R20AY

SECOND FINAL NOTICE

DATE: July 7, 2021
TO: Blue Bird Owners
Subject: R20AY – Steering Wheel Nut Torque Confirmation

SUBJECT: R20AY – Steering Wheel Nut Torque Confirmation

Photo 1

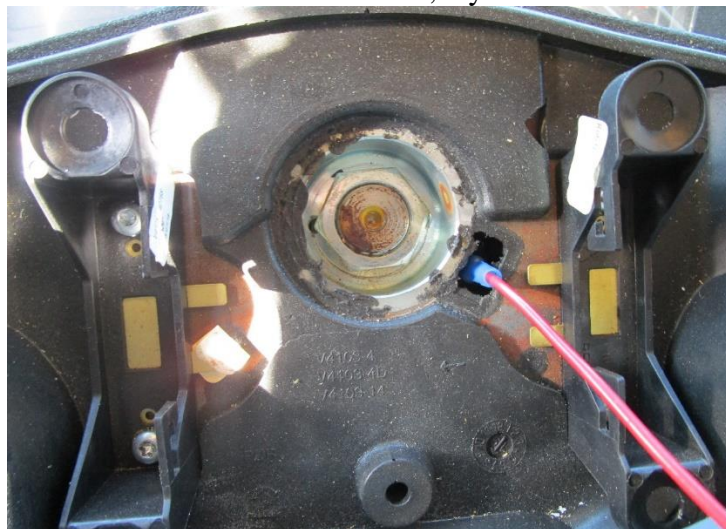
1. Lift up on top of steering wheel cover to remove. See Photo (1)

2. The cover contains the horn wire, lay the cover to the bottom.

3. Torque the steering wheel nut to 40-50ft lbs.
4. Ensure the horn wire is securely connected, then reinstall the steering wheel cover by pressing bottom portion in first followed by top of steering wheel cover until secure.
